STATE OF UTAH
DEPARTMENT OF NATURAL RESOURCES
DIVISION OF WATER RIGHTS

RE: Application No. 426
to Alter Natural Stream

APPLICATION TO ALTER NATURAL STREAM

Include below a diagram or sketch of the channel changes proposed.

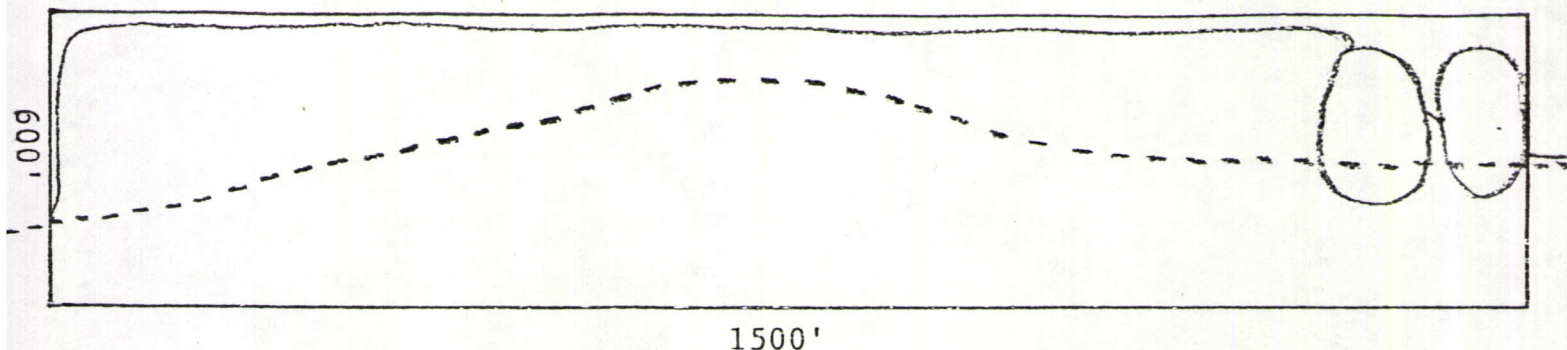
Recommendations of Area Engineer: *Deny until Applicant obtains a Water Right with which to carry out the proposed. RAY 4-20-81*

Your above numbered application to alter a natural channel has been approved pursuant to the requirements of Statute 73-3-29, Utah Code Annotated 1953 and subject to:

1. Sedimentation prevention that will minimize sedimentation in the stream that could have adverse effect downstream.
2. Restoration of Silver Creek to its original meander length and gradient.
3. Obtaining a Water Right, prior to any water use during your project.
